Revisions			
P01	26.06.16	PLANNING ISSUE	AE PY
P02	14.07.16	REVISED PLANNING ISSUE	KI LP
P03	09.03.17	PLANNING AMENDMENT SUBMISSION	NH LP

Project
 TWICKENHAM STADIUM
 EAST STAND EXTENSION

Drawing title
 LEVEL 1 PROPOSED GA PLAN

Doc ref 100-KSS-DR
 Project number 15735
 Drawing number 110
 Revision P03

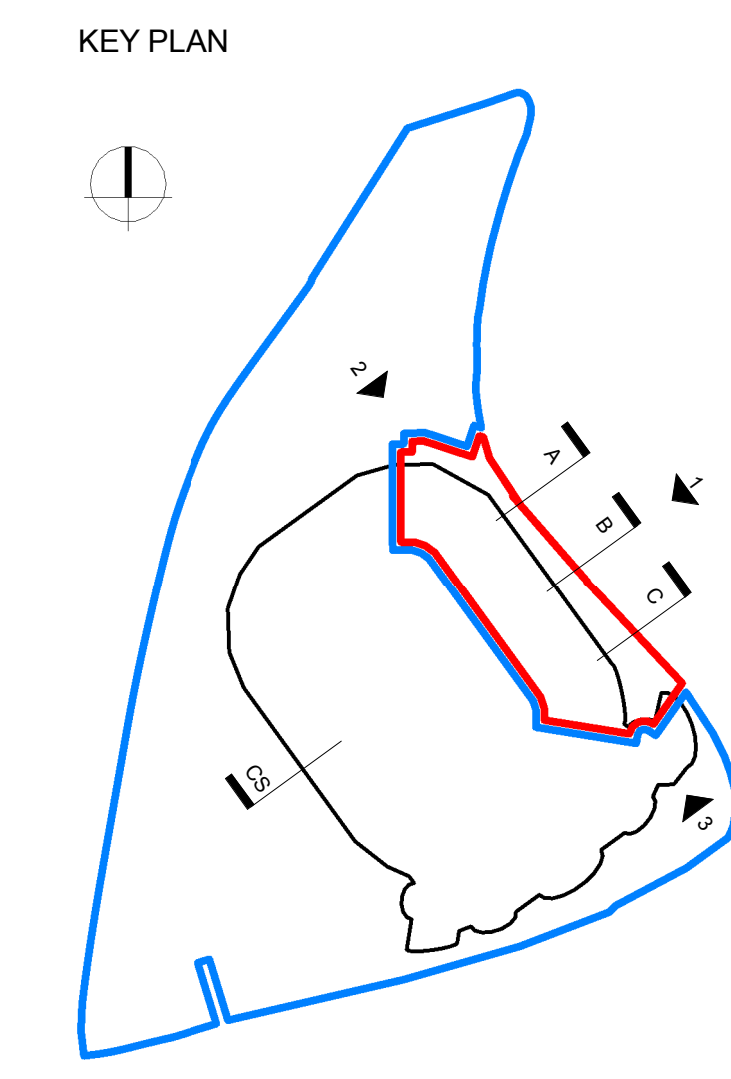
Revision Notes	
PLANNING AMENDMENTS	
A	GENERAL AMENDMENTS TO THE SOUTH END. INCREASED SHINGLES CLADDING AREA AND CURTAIN WALL REDUCED ACCORDINGLY.
A2	REDUCED MASSING AND REVISED INTERFACE WITH THE SOUTH STAND.
B	PPC LOUVRES LOCATED TO THE BOWL SIDE HAVE BEEN OMITTED.
C	CURTAIN WALL SETTING OUT REVISED GENERALLY. SILICONE JOINTS TO TRANSOMS AND MULLION REPLACED WITH CAPPED SYSTEM LEVEL 04 PPC LOUVRES SETTING OUT & HEIGHT REVISED. MONORAIL FOR ABSEILING REMOVED.
D	GENERAL AMENDMENTS TO THE CENTRAL ELEVATION CANOPY AT LEVEL SA REVISED GENERALLY AND STANDING SEAM REPLACED WITH SINGLE PLY MEMBRANE. SUPPORT COLUMNS TO ROOF CANOPY REVISED. SQUARE FASCIA TO ROOF EDGE.
D1	LEVEL SA GLAZED SCREEN EXTENDED IN HEIGHT AND PPC LOUVRES INCLUDED AT LOW LEVEL.
D2	INCREASED SHINGLES CLADDING AREA AND CURTAIN WALL AREA REDUCED ACCORDINGLY. FOUR VERTICAL FINNS REMOVED.
D3	PORCELAIN PANELS WITH SLOTTED HOLES FOR VENTILATION REPLACED WITH PPC LOUVRES. EXPRESSED HORIZONTAL PATTERN TO PORCELAIN PANELS OMITTED.

E	GENERAL AMENDMENTS TO THE NORTH END PORCELAIN CLADDING REPLACED WITH PPC ALUMINIUM CLADDING.
E1	GREEN WALL TO THE NORTH END EXTENDED AND PPC LOUVRES REMOVED.
E2	INCREASED SHINGLES CLADDING AREA AND CURTAIN WALL REDUCED ACCORDINGLY.
F	FENCELINE, GATE AND PERIMETER COLUMNS SETTING OUT REVISED.
F1	CANOPY TO TURNSTILES REVISED.
F2	PORCELAIN PATTERN CHANGED FROM HORIZONTAL TO VERTICAL.
H	PORCELAIN PANELS TO THE SOFFIT OF THE ARCH REPLACED WITH PPC ALUMINIUM PANELS. PORCELAIN PANELS SETTING OUT REVISED.
K	ROOF TO LEVEL SA (NORTH END) EXTENDED.
L	GLAZED SPANDREL PANELS REPLACED WITH METAL SPANDREL PANEL. PORCELAIN PANELS REPLACED WITH PPC ALUMINIUM CLADDING.
L1	PPC LOUVRES INCLUDED FOR MECHANICAL VENTILATION.
